Field Service Bulletin No. 22

ADC Solo
Type 5155 / 100

Path Speed CR SP1001
Type 5155 / 200

Replacement of a broken light barrier flag at the Cassette Opener

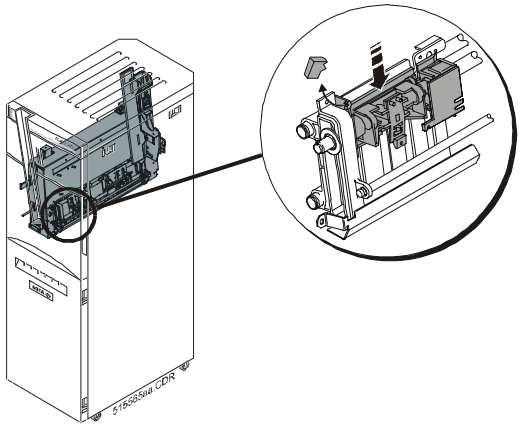
The light barrier flag (see figure beside) of the cassette opener may break when it touches the frame of the cassette opener.

The cassette opener (LHS) remains in the home position and is not moved to the middle position when the cassette holder is lowered manually.

Exchange the broken part.
Order number: **CM+9.5146.5911.0**

Spare part can be ordered separately. It is not necessary to order a complete cassette opener!
